LINCOLN CITY/LANCASTER COUNTY PLANNING STAFF REPORT

for April 13, 2005 PLANNING COMMISSION MEETING

PROJECT #: Special Permit #05017
Ravenwood Community Unit Plan

PROPOSAL: Approve a community unit plan for 44 single-family residential lots.

UTILITY PLAN

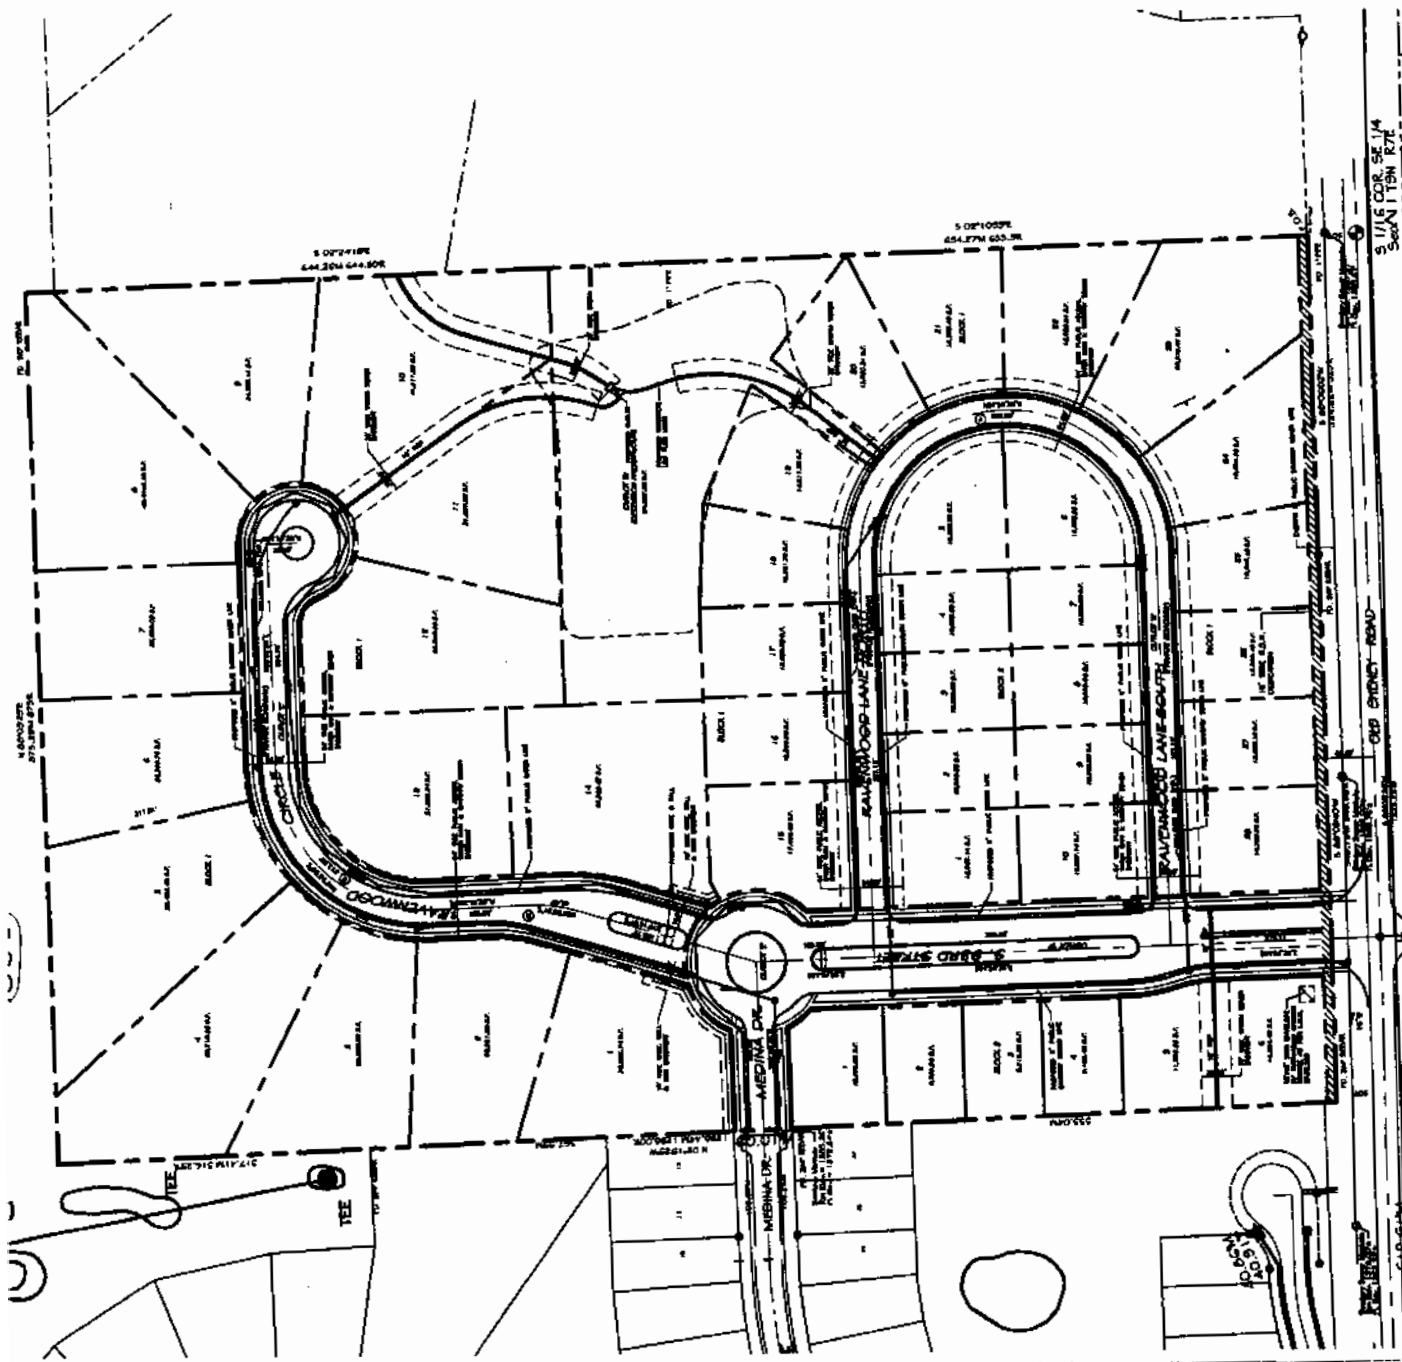
6. Public Works Engineering Services and Watershed Management comments are attached.
7. Additional fire hydrants must be shown to serve this development.

(1.1) Public Works approves the requested waiver of design standards to construct sanitary sewer opposite street grades as justified in the submittal letter. The primary design standard waiver has not been requested but is the reason for the aforementioned waiver. The majority of this plat is in the Stevens Creek Drainage basin. The sewer being connected to is in the Antelope Creek system. The waiver to run opposite street grades, despite 10 feet of fill is due to the crossing of drainage basins.

- 1.1.5 Revise plans as requested in the March 30, 2005 Watershed Management report and the March 31, 2005 Engineering Services report.
 - 1.1.6 Provide additional fire hydrants to the satisfaction of the Fire Department.

GRADING
PLAN

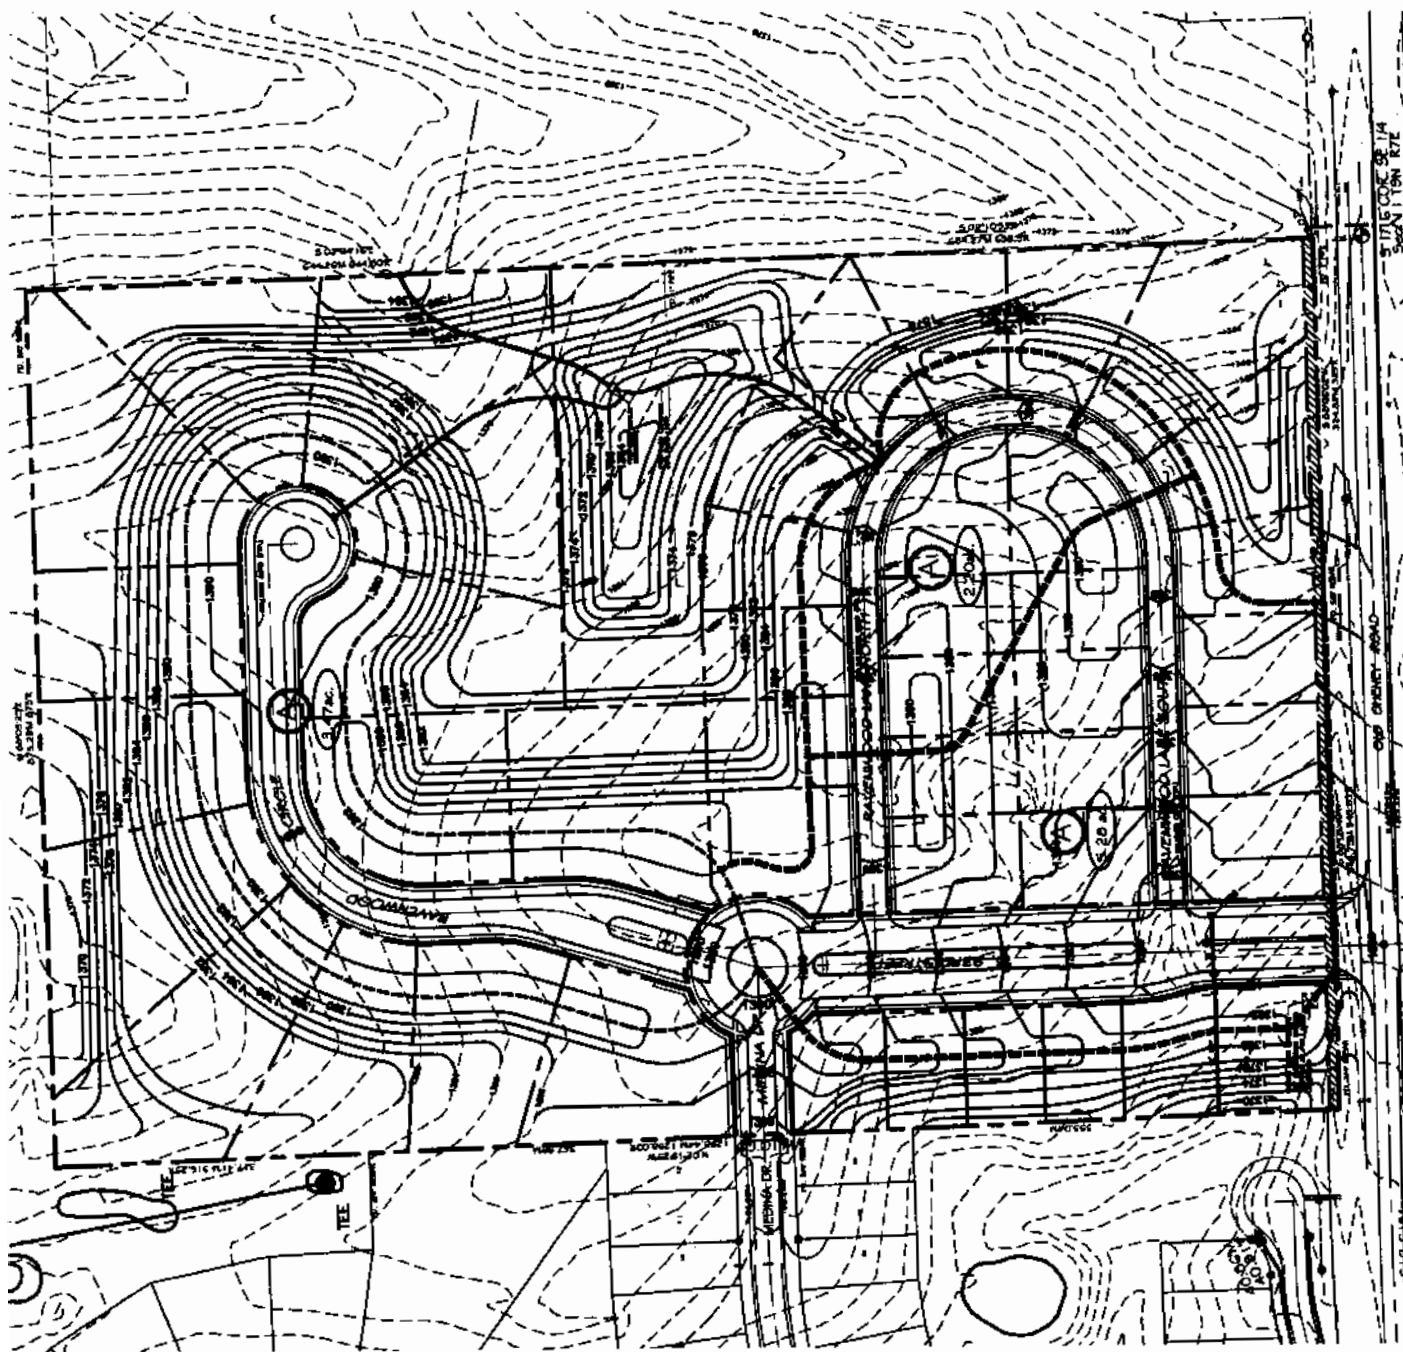
(3.1) The grading plan needs to be revised to show adequate drainage for lots in Block 2. The grading plan indicates excessively flat grades along the rear property lines of numerous lots and will cause drainage problems for future lot owners.

(3.2) The detention calculations show an increased flow for the post development in the SW corner of the plat. This is contrary to design standards and would require a waiver. Public Works would not approve this waiver. The grading plan and/or street grades need to be revised to show that the post developed discharge at this point is at or below the pre-developed flow.

1. Sheet 4 of 5, rational method correction factor for 100-year flows was not included as per Drainage Criteria Manual (DCM) section 2.5.3.3.1
2. Time of concentration used appears to follow guidance for using the rational method, rather than travel time estimation as given in DCM Appendix 2-C. Also, existing and proposed times of concentration are nearly identical.

5. Storm drain outlets appear to extend into detention area. Break between pipe and low flow liner is difficult to discern on plans. Topographic contours at detention cell appear to have inconsistencies. Concentrated flows appear to be discharged onto adjacent property to the east. Evaluate impact of concentrated flows on adjacent property.

6. Proposed conditions discharge in the southwest subarea exceeds existing conditions discharge. Concentrated flows appear to be discharged directly onto the adjacent property. Evaluate the impact of concentrated flows on downstream adjacent property. (Ref. DCM 6.4.2, 6.4.6)

7. Provide plans showing outlet works of detention cell, dimensions, and specifications. Provide information regarding maintenance accessibility of detention cell and show access routes.

8. Provide minimum opening elevations and supporting calculations for lots abutting the detention cell and for those abutting overland flow paths. (Ref. Lincoln Municipal Code (LMC) 26.15.020 (b) 6,7, and 8, and DCM 6.4.4.1)
